Request for Additional Information No. 437, Supplement 8

U. S. EPR Standard Design Certification

SRP Section: 06.02.01 - Containment Functional Design

Question 06.02.01-99:**Follow-up to RAI 221, Question 06.02.01-23**

Figure 06.02.01-99-1—Room UJA07026 Vent Paths

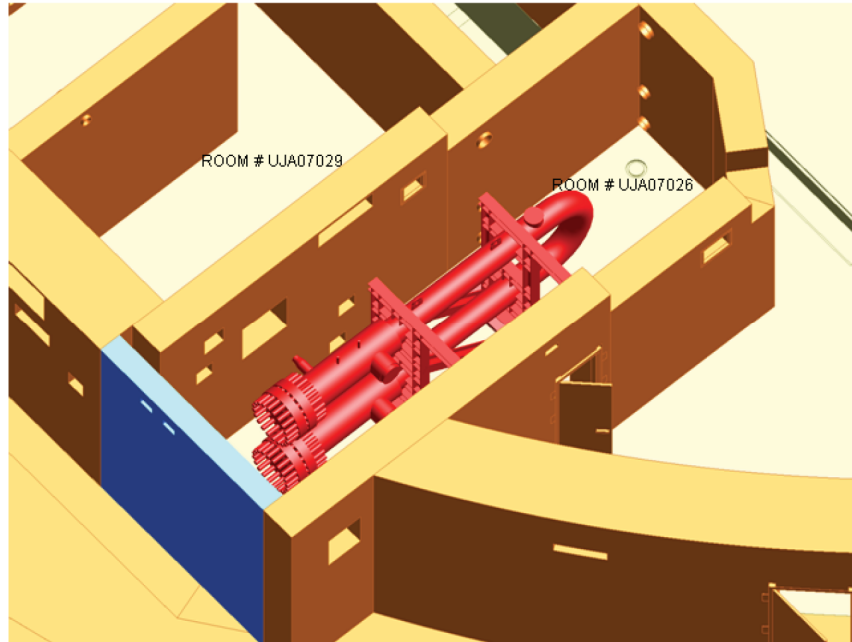
- a. Provide justification that the vents, drains and penetration openings connecting each of these compartments to the bulk containment are adequate to sufficiently equalize before the peak containment pressure is reached for design basis accidents.
- b. The "Net Room Volumes" provided in Table 06.02.01-23-1 differs from the values for the compartments provided to the staff in the response to RAI 40. Provide a comparison between the volumes in the two responses. Identify which values are correct and discuss the reasons for which different values were given.

As shown in Figure 06.02.01-99-1 and Figure 06.02.01-99-2, there are multiple vents/penetrations interconnecting the NIDVS and CVCS rooms UJA07021, UJA07026, UJA07027, UJA07028, and UJA07029. The vents/penetrations from these rooms to neighboring rooms can also be seen in these 3D pictorials.
